PER-005-PAP
Appl. No. 10/658,154

Reply Date: April 1, 2005
Reply to Office Action of December 1, 2004

Amendments to the Drawings:

FIG. 1

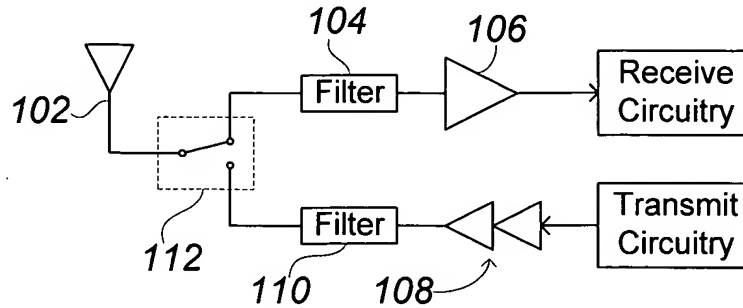
In a "Drawings" section of the current Office Action, the Examiner suggests that Figs. 1-2 should be designated --Prior Art--. FIGURE 1 is herein amended accordingly, but the Applicants respectfully decline to label FIGURE 2 as prior art. The figure suggests a flexible architecture, which, for example, permits a single "fly" capacitor to provide charge to an essentially unlimited number of distinct outputs, and contains material that is not known to be in the prior art. The architecture is "basic" only in that it omits switching details.

Figure 1 has been amended in response to the Examiner's objections thereto by addition of the term "Prior Art" as requested. A replacement first drawing sheet incorporating these changes, together with an annotated first drawing sheet showing changes in red, are attached to this response as an appendix.
